PRODUCT CHANGE NOTICE

1. TITLE Microcircuit, Octal 400 Mbps LVDS Bus Repeater		2. DOCUMENT NUMBER SPO-2012-PCN-0003	
		3. DATE (Year, Month, Date) 2012, February, 22	
4. MANUFACTURER NAME AND ADDRESS CAES 4350 CENTENNIAL BOULEVARD COLORADO SPRINGS, COLORADO 80907-3486		5. MANUFACTURER POINT OF CONTACT NAME Ronald Lake	
		6. MANUFACTURER POINT OF CONTACT TELEPHONE 719-594-8491	
		7. MANUFACTURER POINT OF CONTACT EMAIL ron.lake@cobhamaes.com	
8. CAGE CODE 65342	9. EFFECTIVE DATE 2012, February, 22	10. PRODUCT IDENTIFICATION CODE WD17B	11. BASE PART UT54LVDM328
12. BLANK		13. SMD NUMBER 5962-01536	14. DEVICE TYPE DESIGNATOR 01
		15. RHA LEVELS R, F, G, H	16. QML LEVEL Q, V
		17. NON QML LEVEL C, P	18. BLANK

SIDE VIEW OF PACKAGE

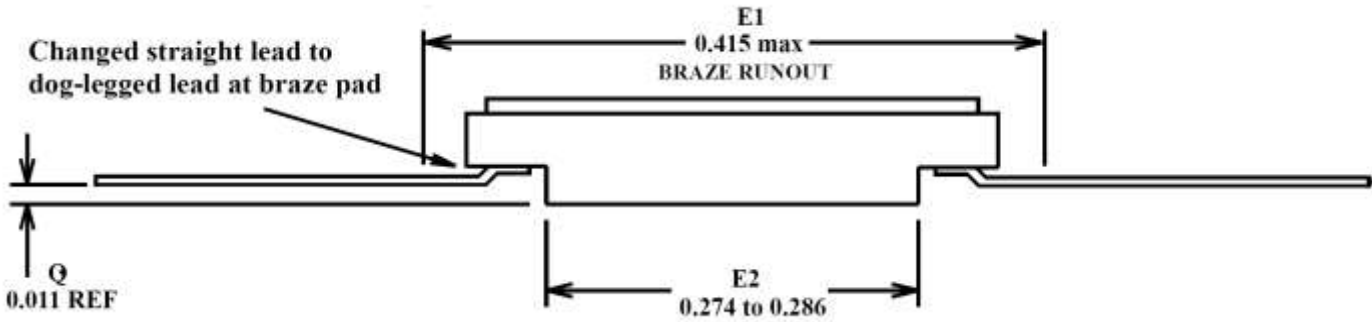
The UT54LVDM328 uses Case Outline Y (as defined in the SMD) or Case Outline U (as identified in the data sheet) to identify the package outline drawing. The package dimensions are changing as noted below. The new drawing also indicates a "dog-leg" bend at the braze point of the leads to the package while the former package drawing indicated a straight lead brazed to the package. These changes will be applied to case outline "U" in the generic product datasheet and the case outline "Y" in the SMD (5962-01536).

CURRENT DIMENSIONS

symbol	inches		millimeters	
	min	max	min	max
E1	0.430	0.470	10.922	11.938
E2	0.180	--	4.572	--
Q	0.026	0.045	0.6604	1.143

CORRECTED DIMENSIONS

symbol	inches		millimeters	
	min	max	min	max
E1	--	0.415	--	10.541
E2	0.274	0.286	6.960	7.264
Q	0.011 REF		0.279 REF
